PREVOST

**SAFETY
RECALL**

SR17-31B

DATE :	May 2018	SECTION :	23 ACCESSORIES
SUBJECT:	2½ lb AND 5 lb FIRE EXTINGUISHER REPLACEMENT

FIGURE 1

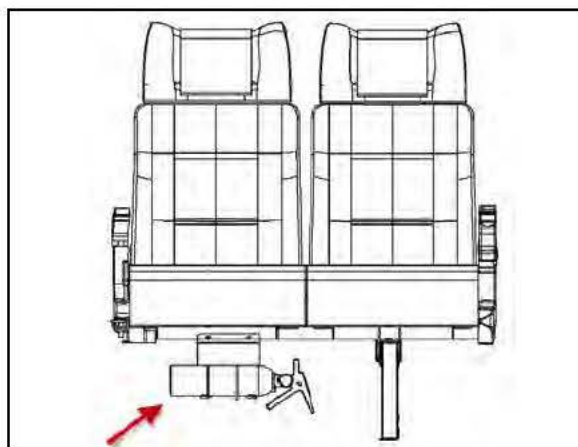
1. Locate all the existing 2½ lb fire extinguishers on the vehicle (Figure 1).

FIGURE 4

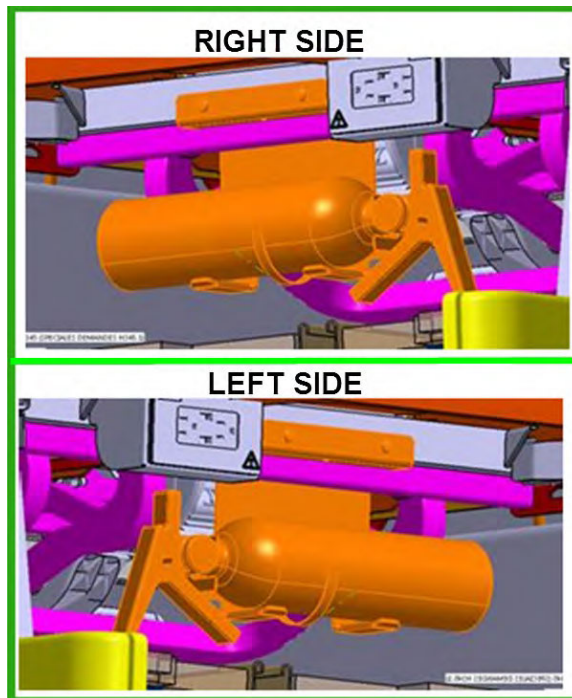
3. To avoid interference between the handle and the seat, orientate both new extinguisher handles down as shown on Figure 4.
4. Bulletin is complete for these vehicle models.

FIGURE 8

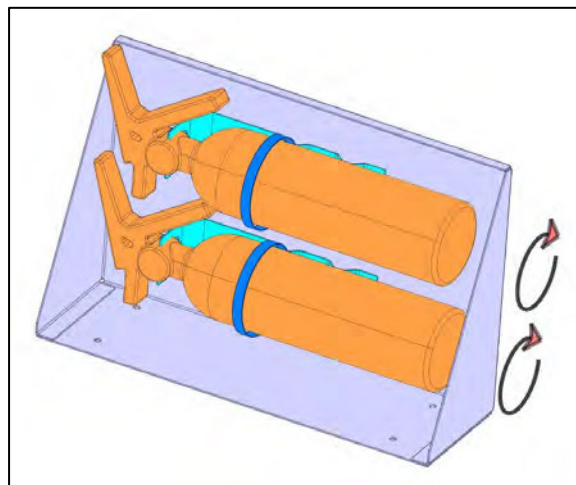
3. To avoid interference between the metal handle of the first fire extinguisher and the cylinder of the second fire extinguisher, turn slightly and apply the same angle to both fire extinguishers (Figure 8).
4. Bulletin is complete for these vehicle models.

FIGURE 9

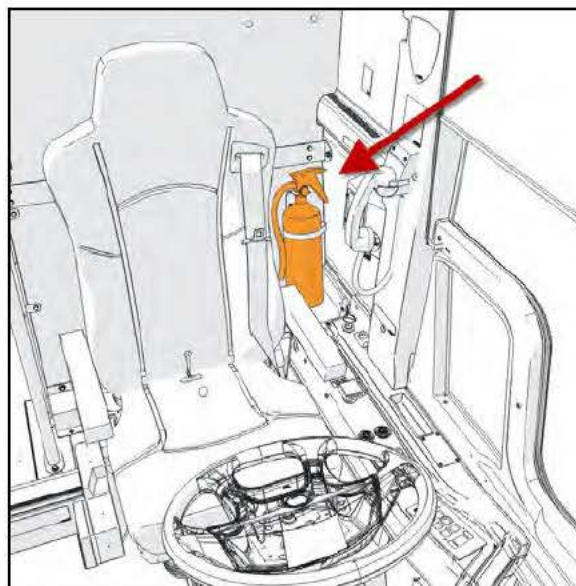
1. Locate the existing 5-lb fire extinguisher behind the driver's seat of the vehicle.

Figure 9 shows the installation when the vehicle was delivered. Location of the fire extinguisher might be different.

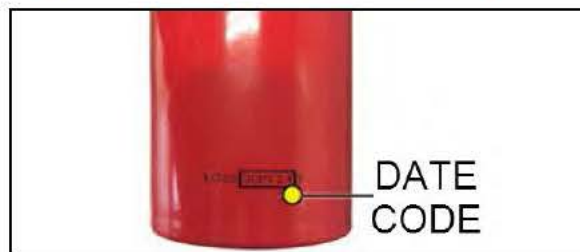
Figure 11 shows the location of the 10-digit date code on the side of the cylinder. Digits 5 through 9 represent the day and year.

All fire extinguishers with the date code XXXX29715X (October 24, 2015) or later have to be replaced.
